REPLACEMENT OF MYNY SEAT LOCKS ON ALL NO. 5, 12, 16, HY-5, AND HY-5-II BIG ELI WHEELS

HY-5 BULLETIN

SUBJECT: REPLACEMENT FOR HANDYMAN JACK

Subject: Bolt Wear in HY-5 Spoke Stack Tenon Chain

SUBJECT: LOADING PLATFORM OVER-CENTER LINKAGE

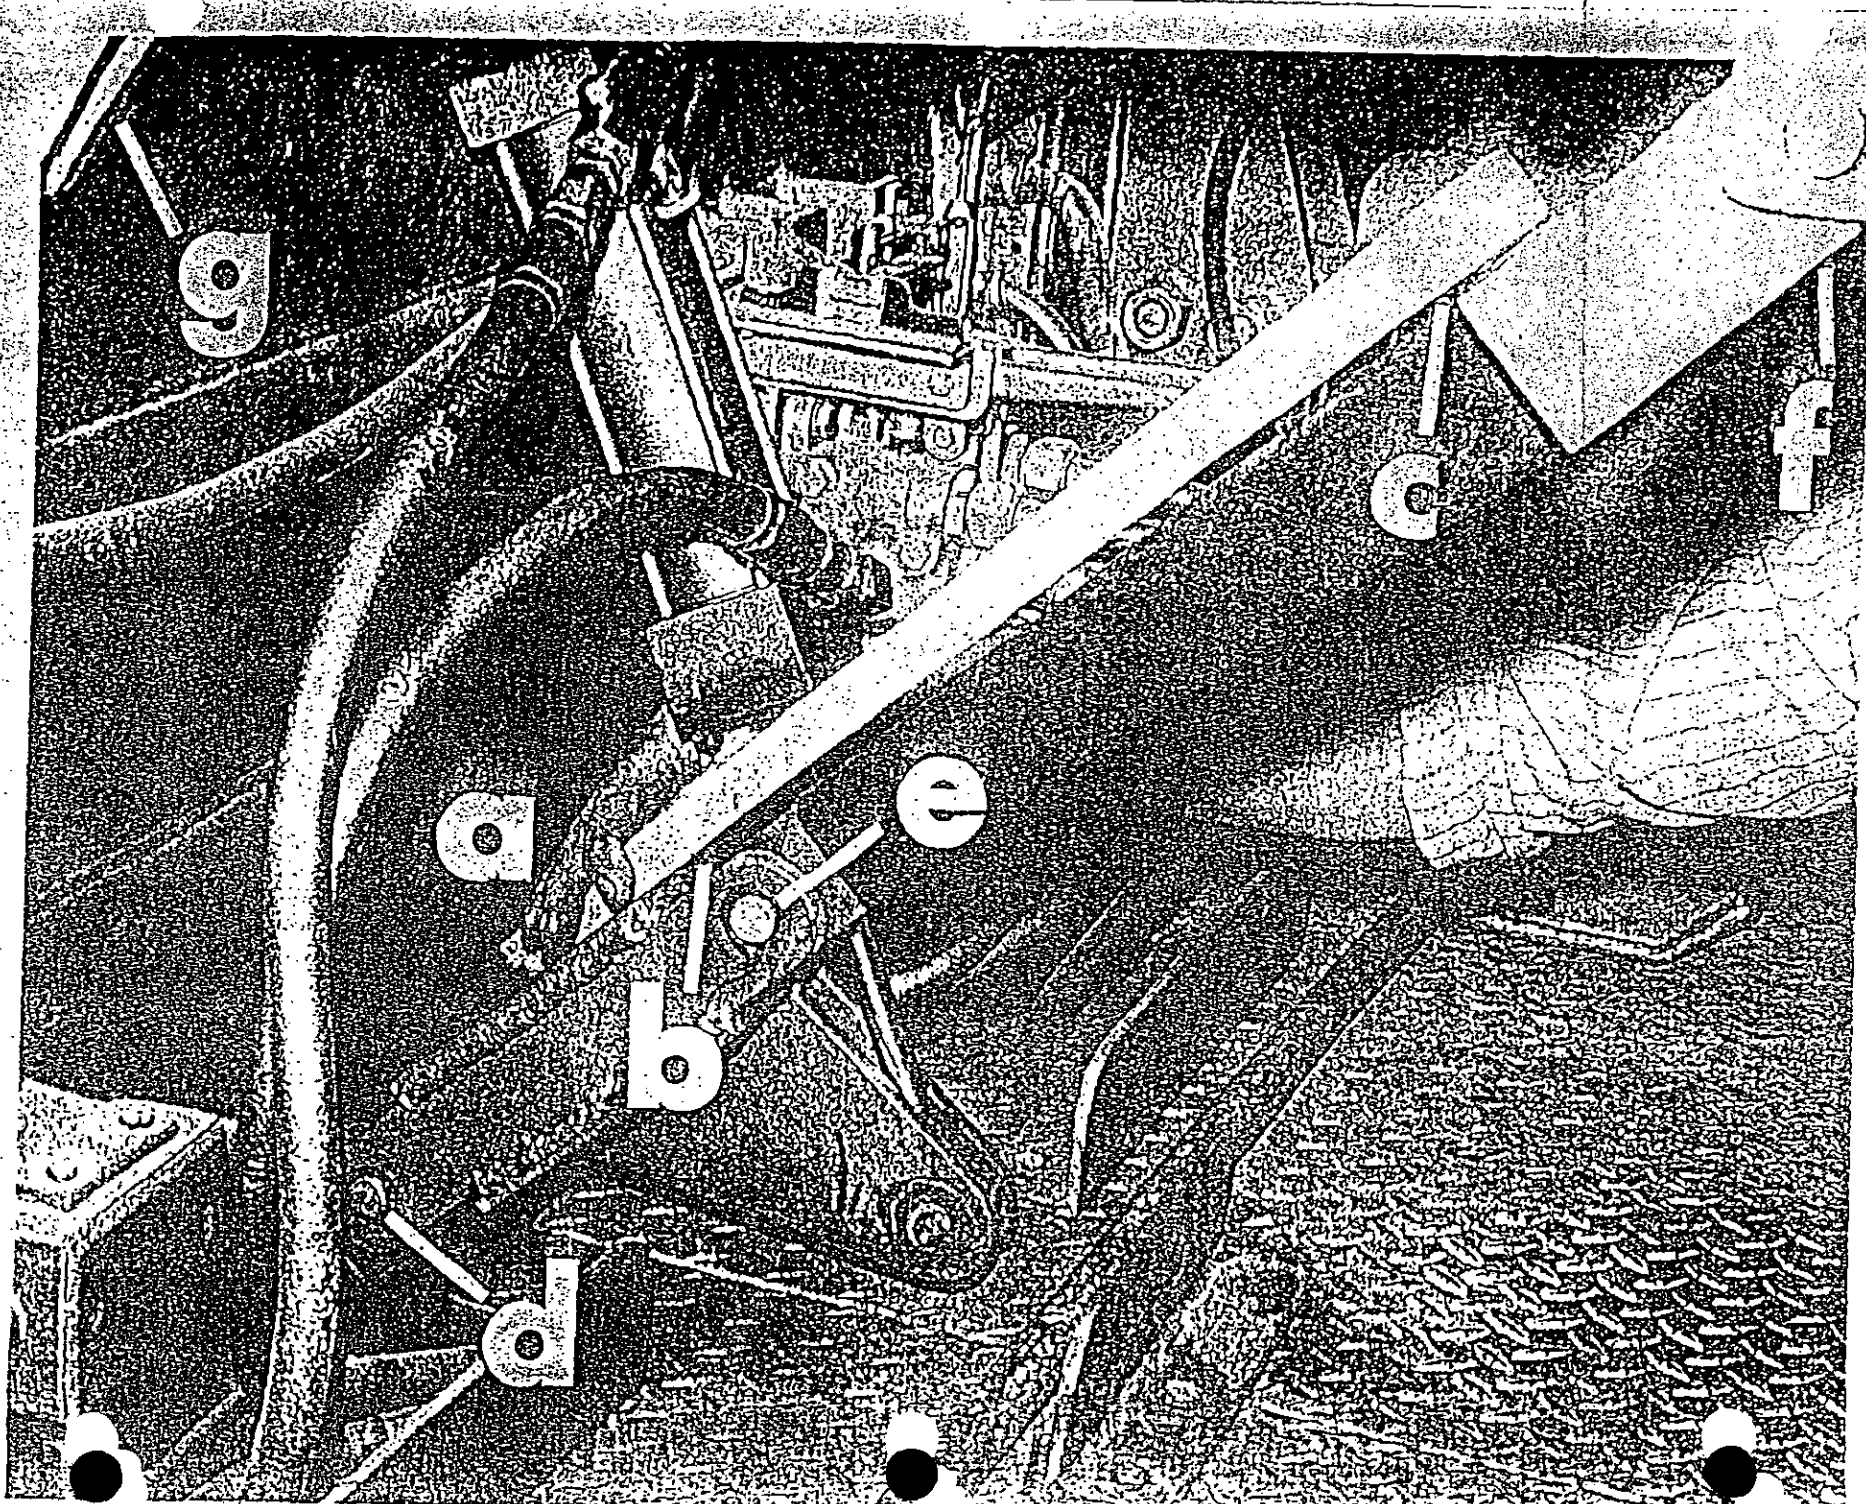
Check the linkage as shown in the photograph by positioning a straight board or bar (b) on the lower link (a), and observing the position of the other end of the board at (c). If the linkage is over-center, there should be less space between the board and upper link at (c) than there is at (b). If the space at (c) is greater, then corrective action must be taken.

Originally, the pins at (d), (e), (f), and (g) were 3/8" diameter and turned on nylon bushings. The holes for the bushings were 7/16" in diameter.

Ream the pin holes at (d), (e), and (f) to 1/2" in diameter, and install 1/2" pins, cotter keyed on each end. The two ends of the cylinder must be left as is, or interchangeability with a replacement cylinder will be affected.

It is nearly impossible to ream out the pin connections at (g) because the holes are quite close to the wall behind, and so we recommend that these holes, which are located at the rear side of the loading platform, be left alone.

SUBJECT: REPLACEMENT OF RACINE HOLDING VALVE WITH REPUBLIC PUSH VALVE ON HY-5 TRIPLE EXTENSION CYLINDERS WHICH RAISE AND LOWER THE TOWERS

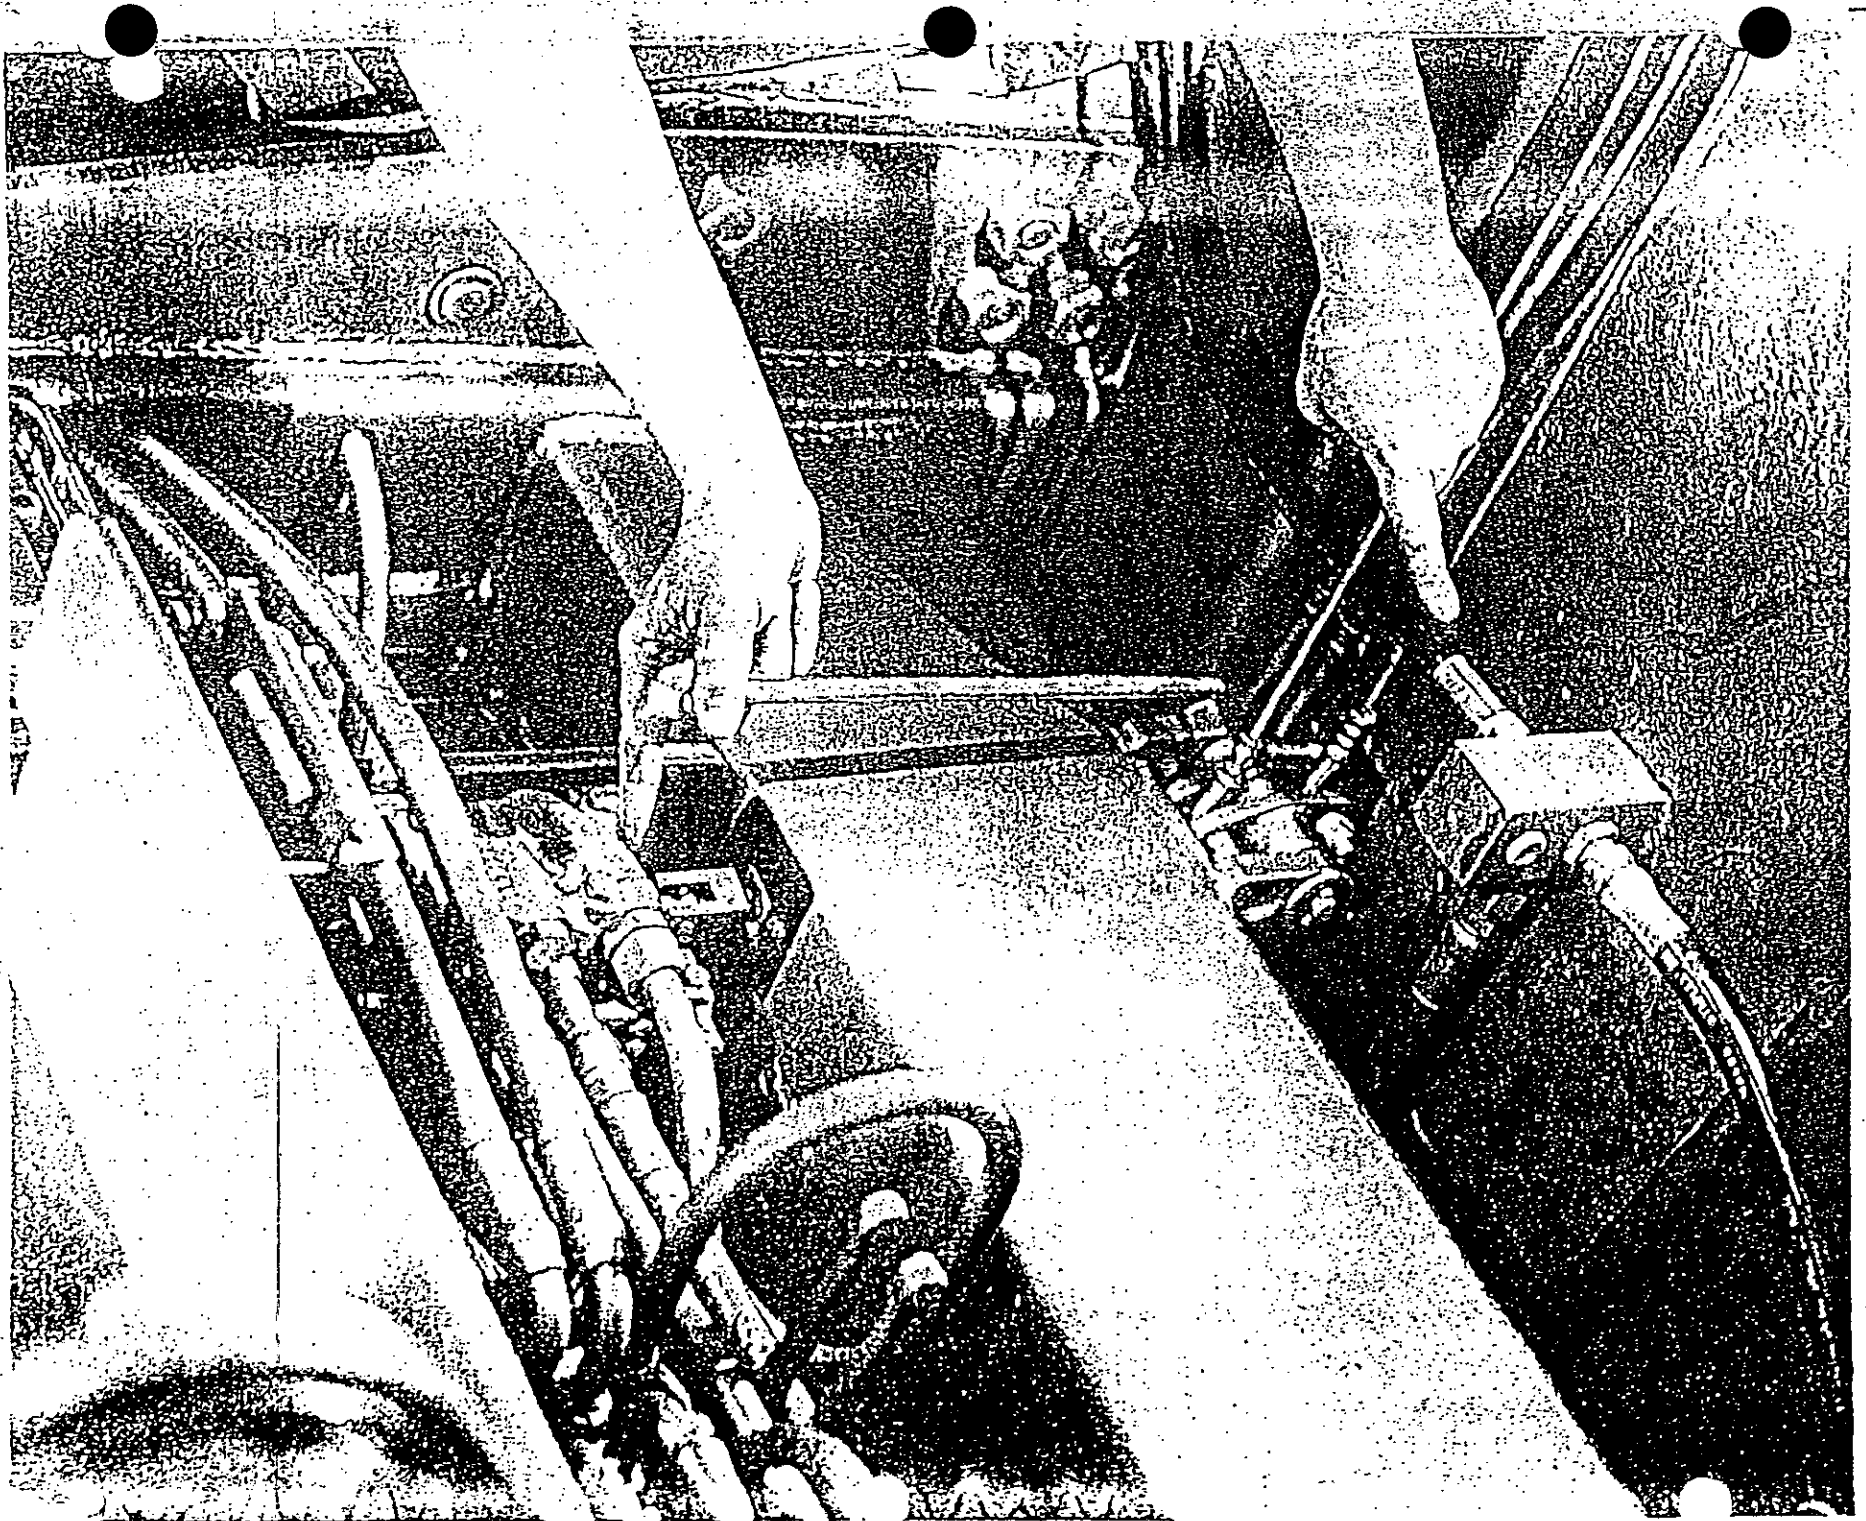
When installed properly, oil flows unimpeded through the valve for raising the towers. Oil will not flow out of the cylinder at any time unless the palm button, shown in Picture No. 2, is pressed. No pilot pressure is required, so there is no back pressure for the winch to work against. After the towers break over center, you do not need the winch at all.

It is necessary to have at least two men to lower the towers, one on each side to

operate the palm buttons on the Republic valves. It is still necessary, of course, to operate the winch and cylinder valves as before.

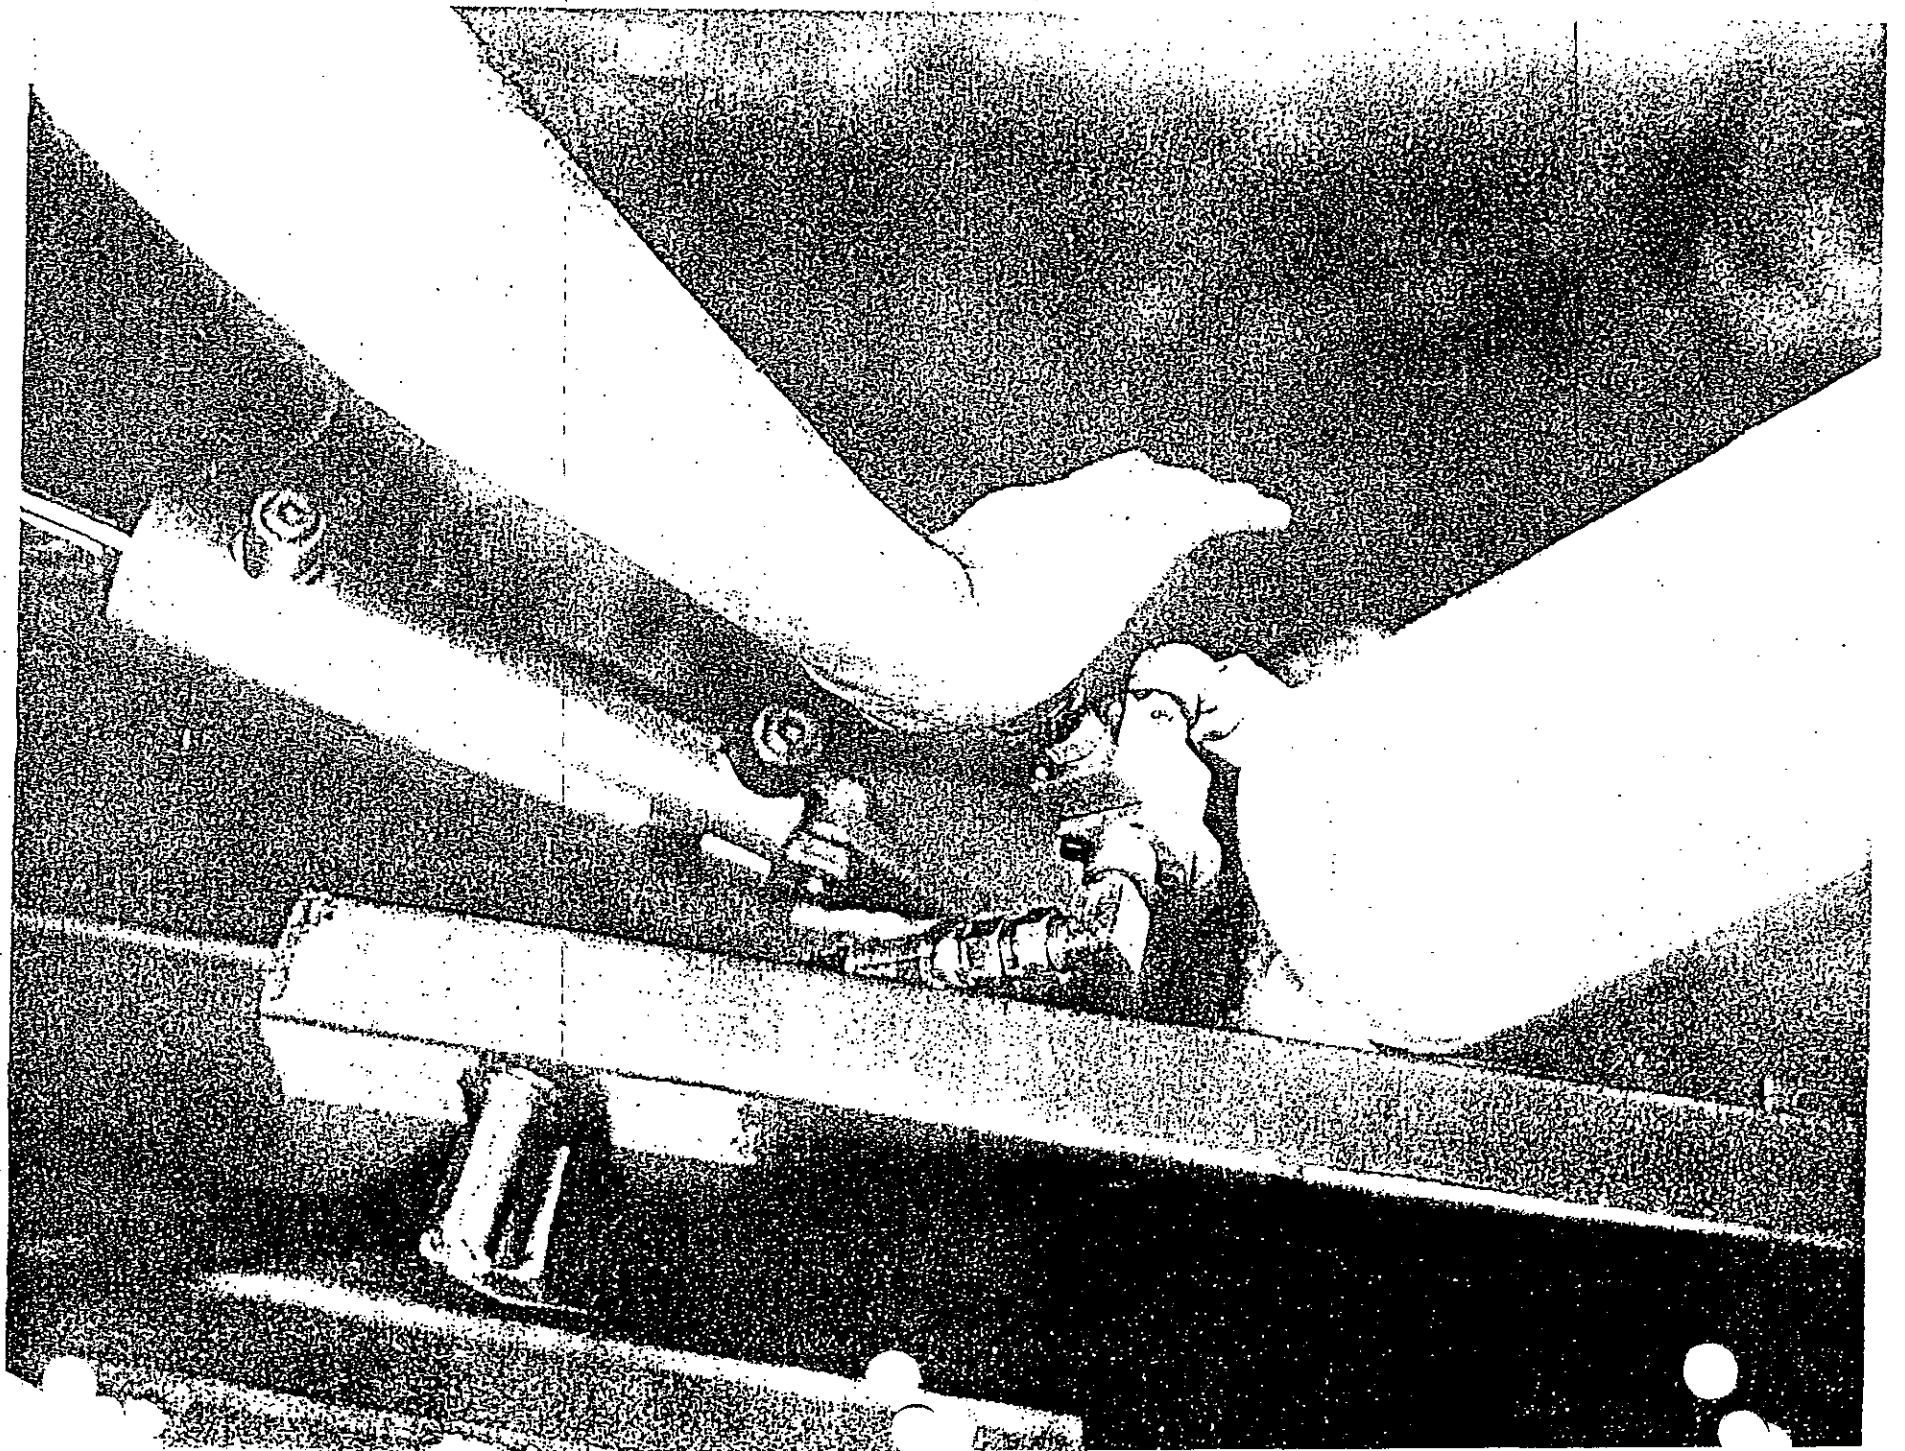
Besides replacing the Racine holding valve with pilot assist for the Republic push valve, shown in Picture No. 2, it is necessary to modify the plumbing to the manifold block on the floor of the trailer, and to replace the directional control valve higher up in the trailer. Both are shown in Picture No. 1.

Figure 1

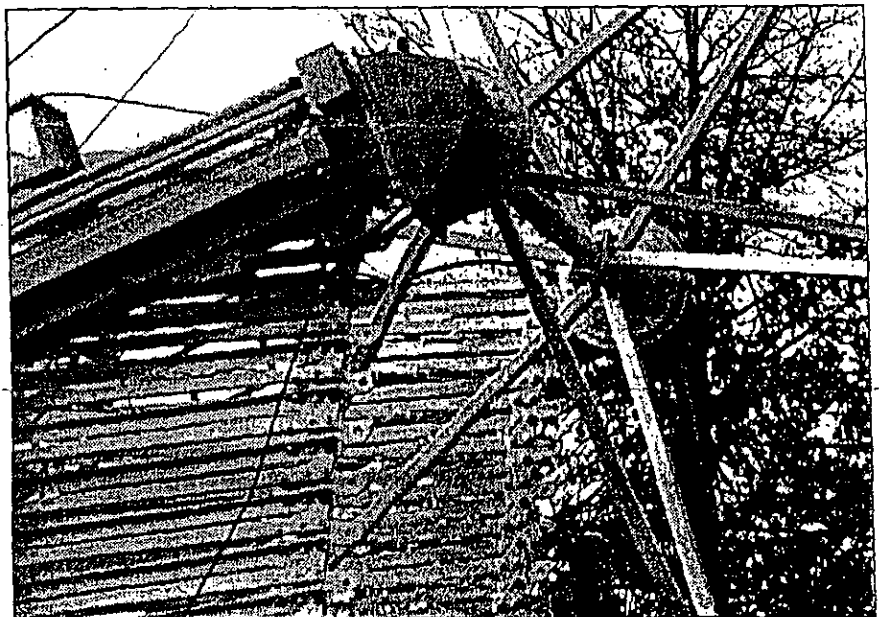
Inspecting for wear can be done quite easily with the Wheel folded for transport as shown in Figure 1. Inspecting the bolts can be accomplished without removing the bolts which would cause the spoke stack to fall. All of the bolts should be inspected one at a time by looking at the bolt where the spoke connection plates bear against it. This can be done by loosening the nut on each bolt which attaches the spoke connection plates and the spoke tenon.

Figure 2

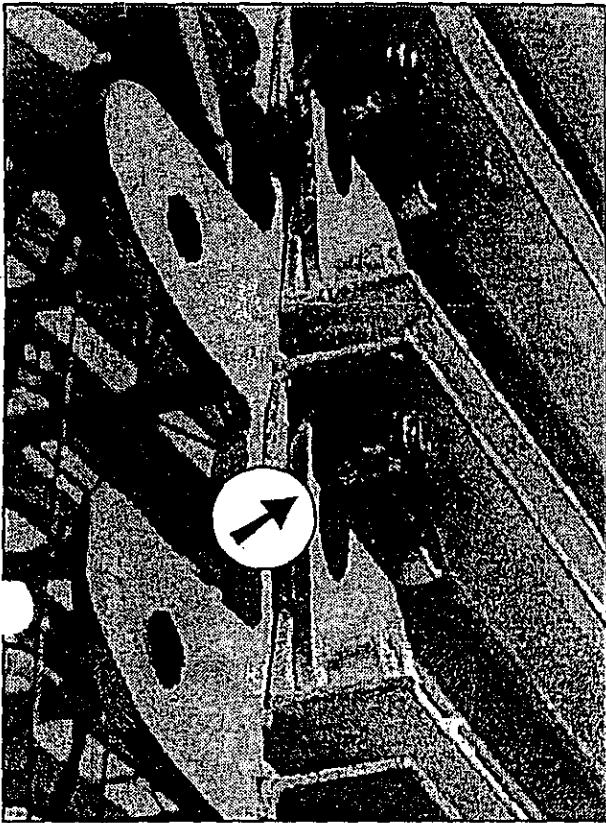
With the nut loosened, move the washer away from the spoke connection plate enough so that the bolt, indicated in Figure 2, can be seen where the inside spoke connection plate bears against it. A worn bolt will have a smaller diameter where the spoke connection plate makes contact with it. The original equipment bolt is $.500''$ ($1/2''$) in diameter. If you can see that any part of the bolt is worn by as much as $.0625''$ ($1/16''$) as shown in Figure 3, the bolt must be replaced.

However, do not tighten the nut so much that the joint will not be able to pivot. This means the nut will be free to turn on the bolt unless double nutted as shown in Figure 2, or unless self-locking nut is used.
